Printable View (215 KB)	
TSB 07-14-1	<ul style="list-style-type: none"> • DAMAGED SPARK PLUG ELECTRODE/MIL DTC P030X
Publication Date: June 27, 2007

FORD: 2006-2007 Freestar
MERCURY: 2006-2007 Monterey

Figure 3 - Article 07-14-1

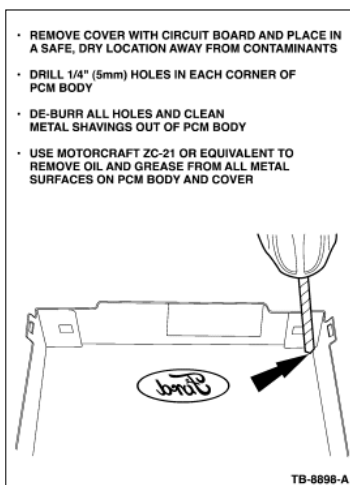
4. Set the PCM top plate in a clean, dry location where the circuitry will be protected from damage.
5. With the PCM cover removed, drill a 1/4" hole on each of the four (4) corners of the PCM cover. Get as close to the corner as possible. (Figure 3)

6. De-burr the edges on both inside and outside surfaces. (Figure 3) Be sure to vacuum off all chips and wipe off all metal dust and any machining oil.
7. Clean the surfaces of the PCM cover with Motorcraft ZC-21 (Metal Surface Cleaner) or equivalent. Also clean the edges of the PCM top plate. The

Figure 8 - Article 07-14-1

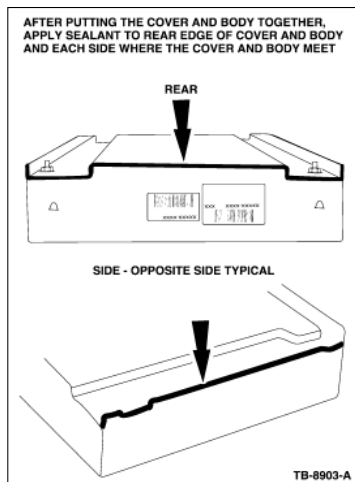
9. Carefully blow off the PCM internals with filtered, dry air at 5-10 PSI (34-kPa) to ensure all components are dry and clean.
10. Reassemble the PCM, and bend the retaining clips back fully. Make sure a full seal is created around the top edge of the PCM - add sealant as required. (Figure 8)

Figure 9 - Article 07-14-1

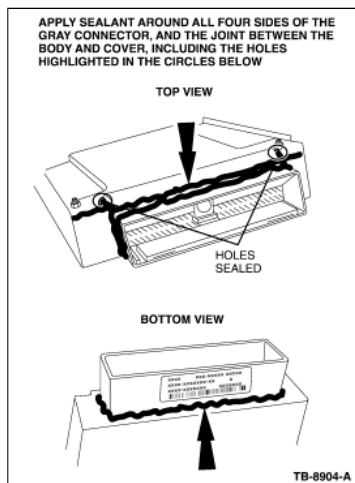
- Apply Motorcraft TA-29 Ultra Silicone Sealant around all four sides of the gray header where it meets the PCM sheet metal. (Figure 9)

NOTE: ALLOW 1 HOUR FOR SEALANT TO DRY PRIOR TO INSTALLING PCM.
